**Flood Control Project Maintenance
Levee Inspections
Fall 2022 Levee Maintenance Deficiency Summary Report**

Reclamation District No. 0556 Upper Andrus

Levee Inspection Report By Mile - Fall 2022

Photo 1 of 1 : FA_2022_RD0556_18_48_20221004_00183.jpg

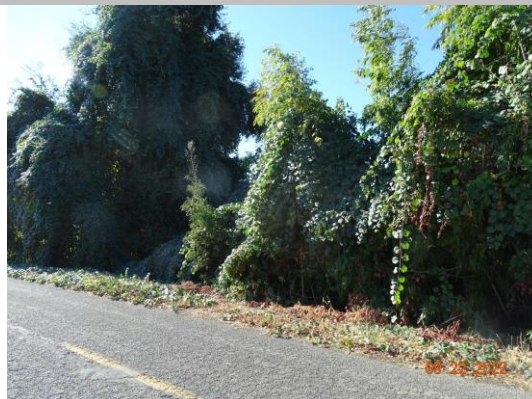
LM Start	2.72	Rating **	U	Issue No.	48
LM End	2.72	Issue Type +	En	Location *	LS
Category	Earthen Levee			GPS Latitude/Longitude	
				Start	End
Item	Vegetation			38.215085 °	38.215085 °
				-121.540724 °	-121.540724 °
DWR ID	DWR_RD0556_01_f_2018_48				
Comment Code					
V6 : Landscaping					
Inspector Comment					
Remove wild grapes and bamboo from landside.

Photo 2 of 2 : FA_2022_RD0556_18_37_20220831_00020.jpg

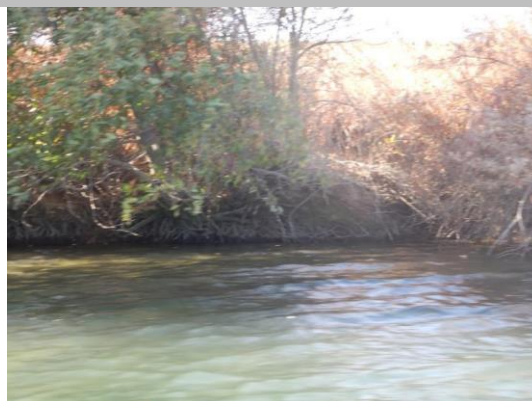
LM Start	2.85	Rating **	M	Issue No.	37
LM End	2.98	Issue Type +	Ma	Location *	WS
Category	Supplemental			GPS Latitude/Longitude	
				Start	End
Item	2018 USACE Erosion Survey			38.214144 °	38.212577 °
				-121.538692 °	-121.537244 °
DWR ID	DWR_RD0556_01_s_2022_37				
Comment Code					
Inspector Comment					
2018 Site ID: GEO 9.2 R					
Status: Eroding					
2018 Field Notes: New erosion along toe.					
Site History: 2017 - Toe erosion.

LM Start	2.85	Rating **	M	Issue No.	37 (cont)
LM End	2.98	Issue Type +	Ma	Location *	WS

Photo 1 of 1 : FA_2022_RD0556_18_86_20220831_00048.jpg

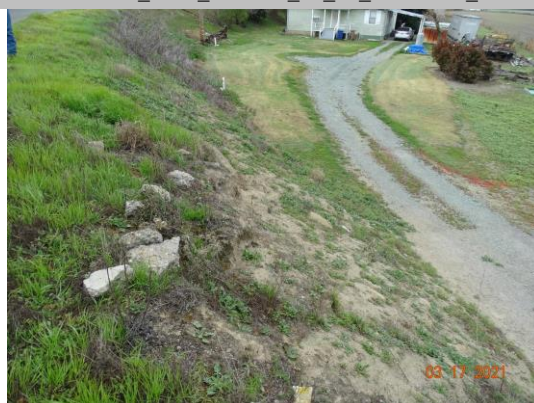
LM Start	3.82	Rating **	M	Issue No.	86
LM End	3.82	Issue Type +	Ma	Location *	LS
Category	Earthen Levee			GPS Latitude/Longitude	
				Start	End
Item	Erosion / Rills			38.202481 °	38.202481 °
				-121.540839 °	-121.540839 °
DWR ID	DWR_RD0556_01_f_2021_86				
Comment Code					
E5 : Schedule repair of rills prior to the next inspection.					
Inspector Comment					
Exposed slope eroding, most likely due to runoff.

Photo 1 of 1 : FA_2022_RD0556_19_68_20220831_00049.jpg

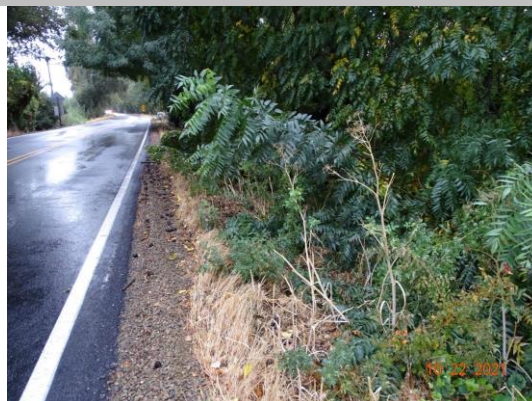
LM Start	2.02	Rating **	U	Issue No.	68
LM End	2.06	Issue Type +	En	Location *	WS
Category	Earthen Levee			GPS Latitude/Longitude	
				Start	End
Item	Vegetation			38.239807 °	38.239409 °
				-121.554221 °	-121.554889 °
DWR ID	DWR_RD0556_02_f_2021_68				
Comment Code					
V6 : Landscaping					
Inspector Comment

Photo 3 of 3 : UCIP_FA_2022_76303_113531.jpg

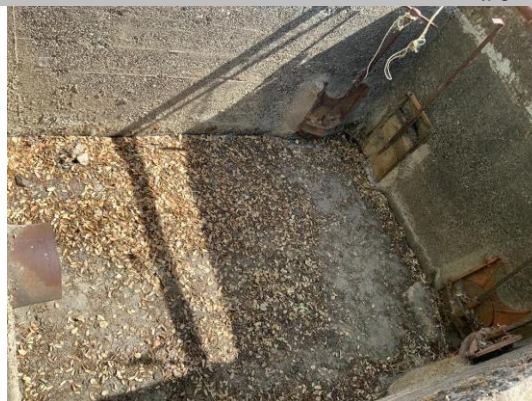
LM Start	3.07	Rating **	U	Issue No.	127 (cont)
LM End	3.07	Issue Type +	En	Location *	
Category	Supplemental			GPS Latitude/Longitude	
				Start	End
Item	DWR UCIP Field Study			38.226225 °	38.226225 °
				-121.555236 °	-121.555236 °
DWR ID	20862
